PLANNING COMMISSION MEETING STAFF REPORT

NAME OF PROJECT: Saddle Creek Subdivision

Subject: Saddle Creek – Phase 1 – Preliminary Review

Horrocks Engineers recently reviewed the Saddle Creek Phase 1 plans for the Preliminary Review. The following issues should be addressed.

PRELIMINARY STREETS & TRAILS PLAN - PHASE I

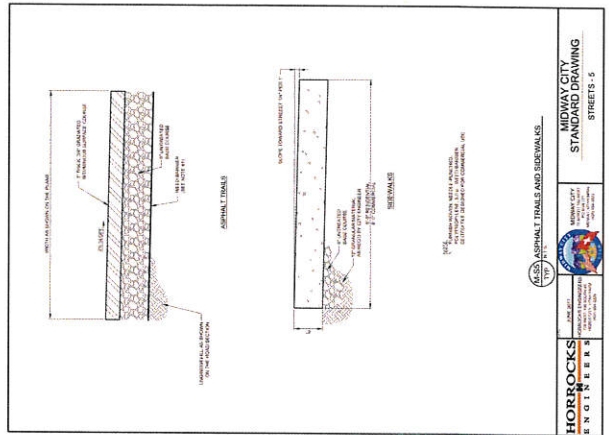
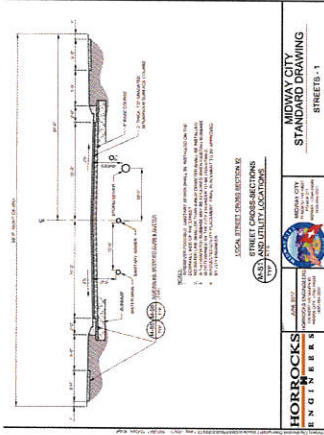
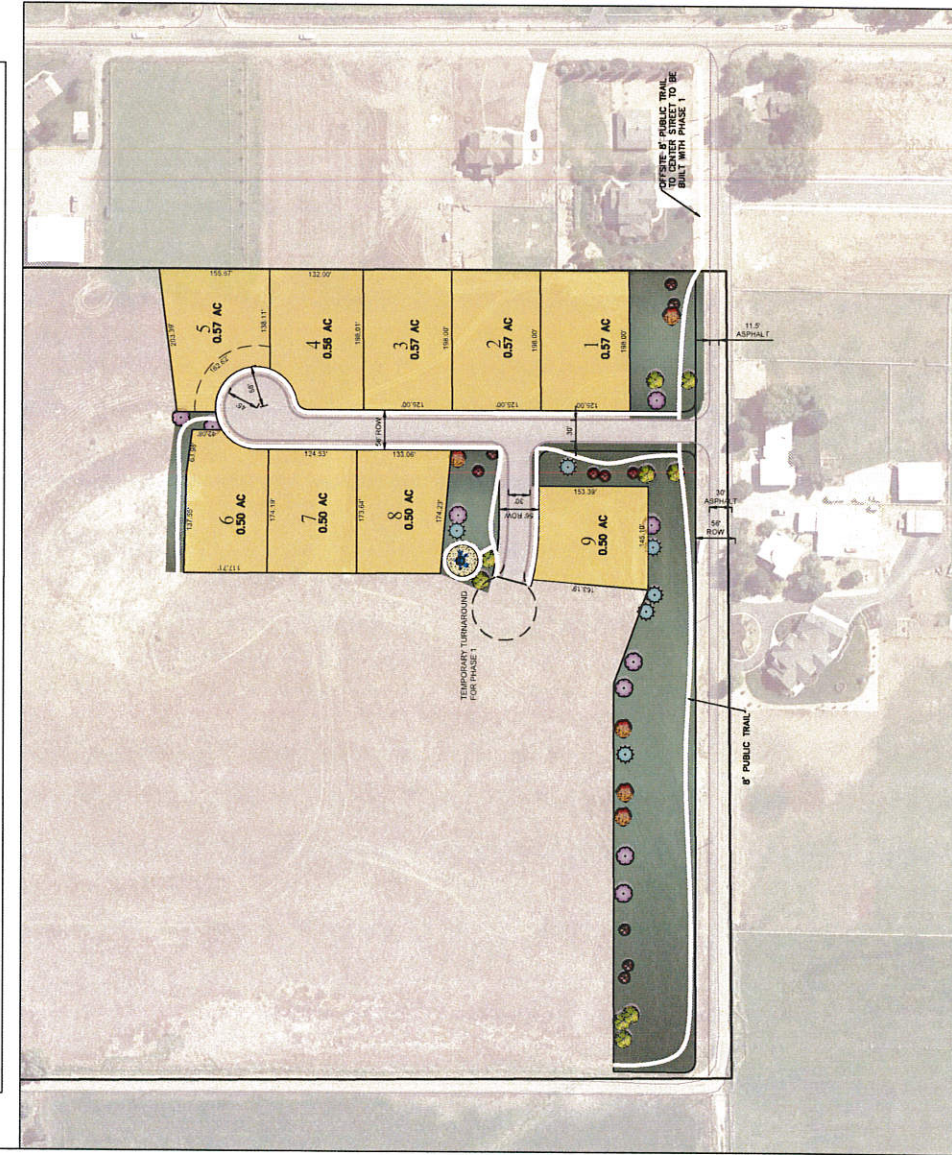
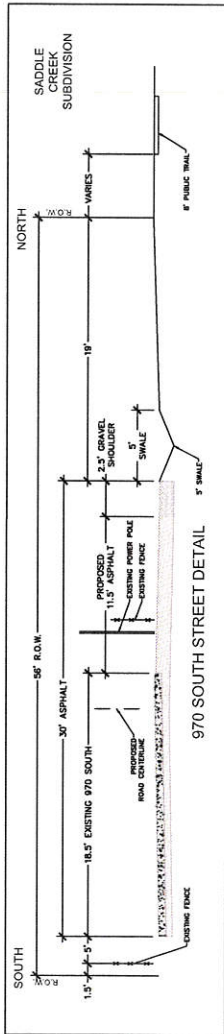
- The proposed road within Phase 1 will be a 56' public right-of-way, with a cul-de-sac to the north and a temporary turnaround at the phase line.
- 970 South Roadway will be rebuilt and widened to 30' of asphalt from Center Street to 250 West.
- The Center Street improvements shall be shown on the approved Preliminary plans.

- An 8' public trail is shown adjacent to 970 South from Center Street to 250 West. 8' trail is also shown within the subdivision.

LANDSCAPE PLAN - PHASE 1

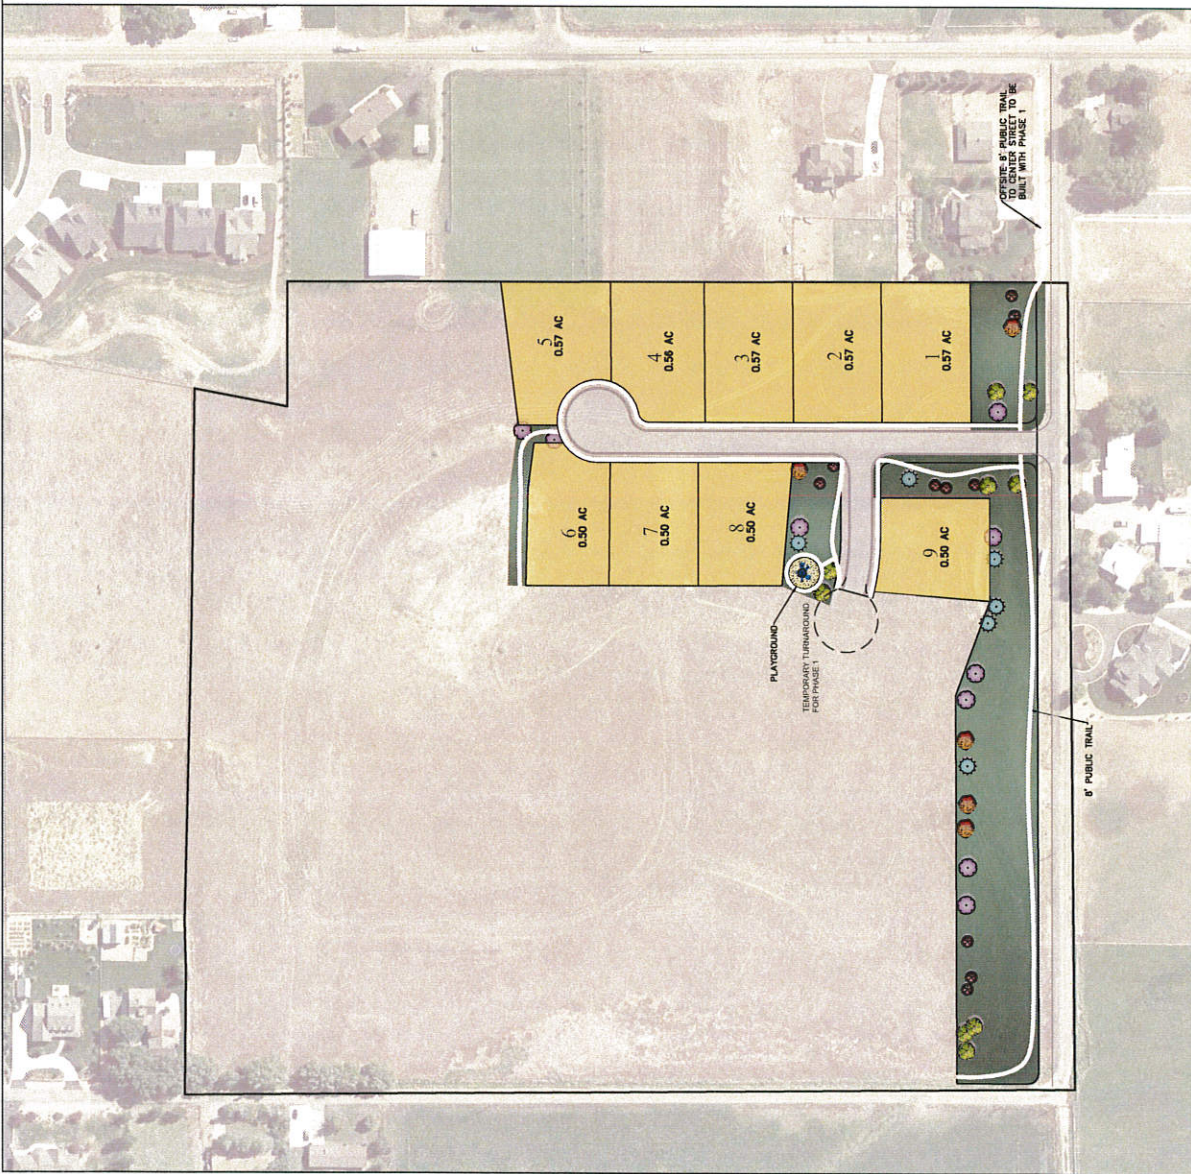
- The proposed landscaping cost shall be included within the improvements bond.
